ADDENDUM TO THE GRASS CATCHER BLOWER

FORM NO: 43776 (4-87)

PART NO: 41751

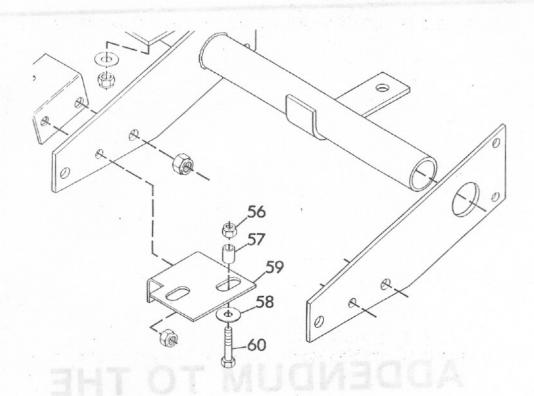
Refer to the Grass Catcher Blower manual, Form No. 41760 (9-86), pages 7 and 8. Revise Item No. 21, Part No. 36987 to 43775, V-Belt. Also, add Item Nos. 56-60 as shown below.

ITEM			DIAJ CCARU
NO.	PART NO.	QTY.	DESCRIPTION
56	456004	1	Nut, Lock 3/8-16
57	11936	1	Bushing, .407x.625x.812
58	446470	1	Washer, Flat .375x1.125x.065
59	43872	1	Bracket, Rear Hitch Centering
60	180130	1	Bolt, Hex 3/8-16x2.00

Refer to page 12. Revise 5.10 to read as follows:

Swing the vac support bracket so that the holes align 5.10 with the hitch. Install a 5/8-11x2 bolt and 5/8-11 lock nut in the rear hole and a 1/2-13x2 bolt in the center hole. Put the rear hitch centering bracket followed by a 1/2-13 lock nut on the 1/2-13x2 bolt. Tighten all of See Figure 5 and the the bolts in the hitch. Fasten the centering bracket to the illustration. bottom of the engine with the 3/8-16x2.00 hex bolt, flat washer, bushing and 3/8-16 lock nut as shown in the The slot in which the hardware is shown illustration. is the correct position for 16, 18 and 20 H.P. units. The 12 H.P. units use the other slot.
